**Re: Project: APP-Sub 450 #2  
Shadowglen Ph 3 Sec 1 & 2**

Please accept this Comment Response Letter in reply to the Traffic Engineering Division review, dated January 24<sup>th</sup>, 2023, regarding the above-referenced project. Original comments have been included below for reference. All Kimley-Horn's responses are listed in **Blue**

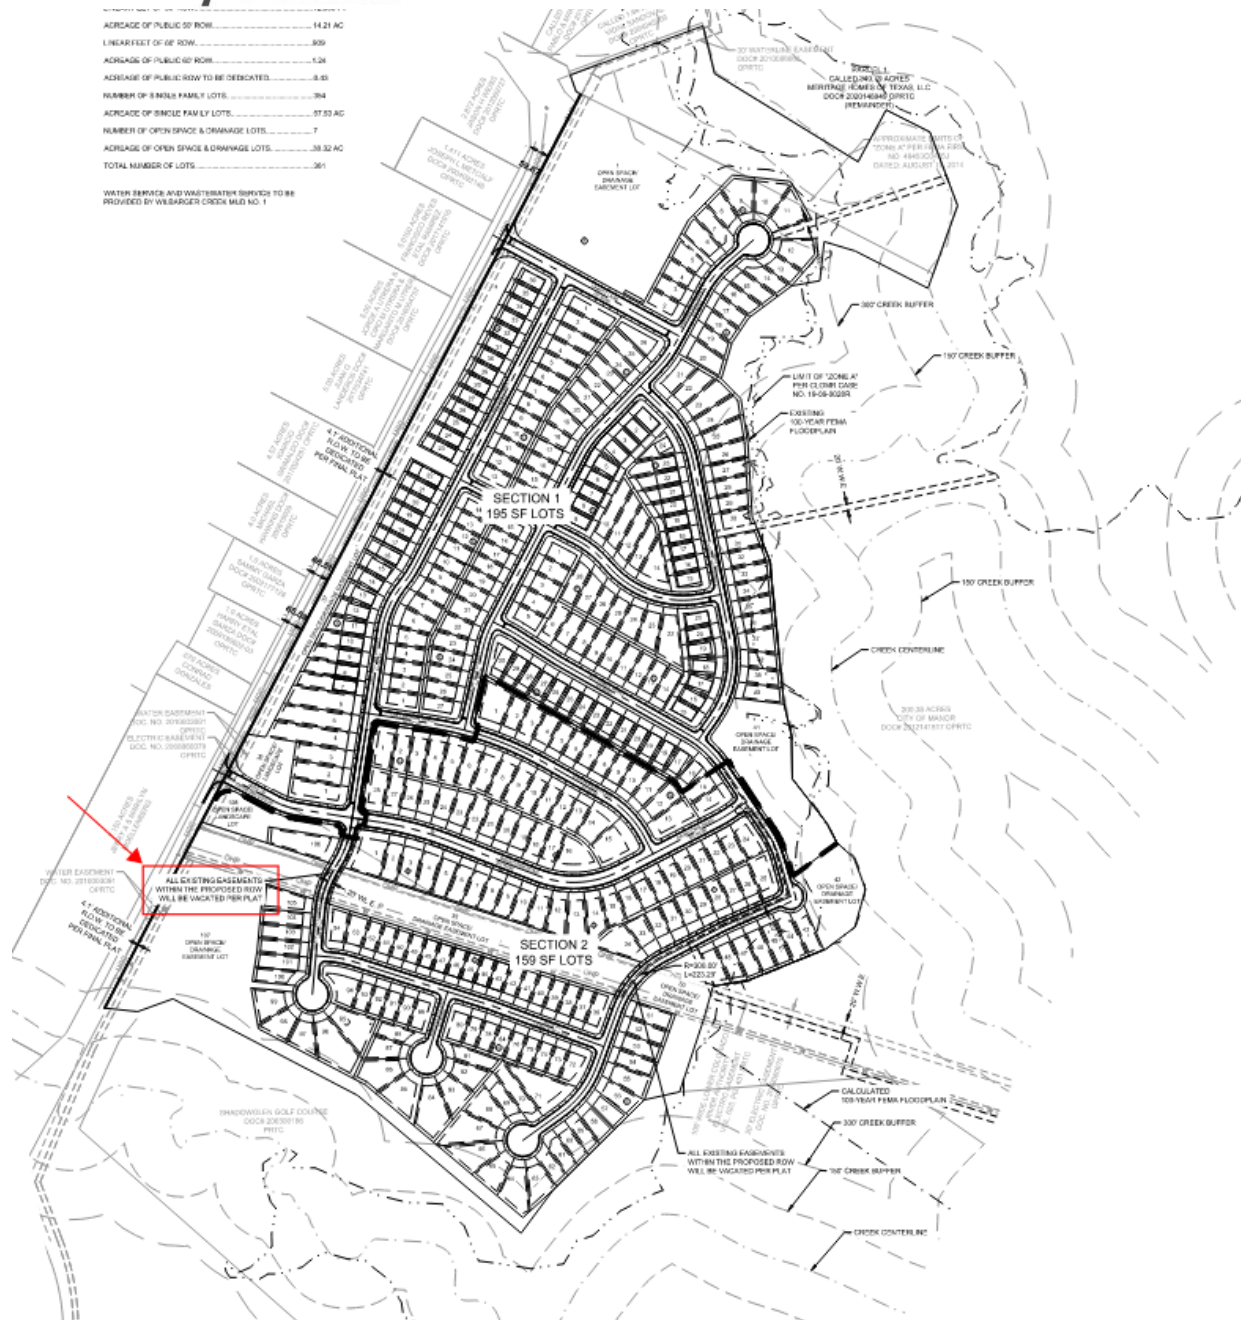
**Comment 16:** Designate any existing easement crossing a proposed right-of-way as to be vacated on the plan. Rights-of-way must be clear of any encumbrances or entitlements in order to be accepted by Travis County for maintenance. 5/23/19 – Revise preliminary plan as requested.

Update comment 1/23/23: Please confirm the location of the note; I did not find it on the Preliminary Plan.

**Response: Acknowledged. The vacation note is shown below on the overall preliminary plan.**
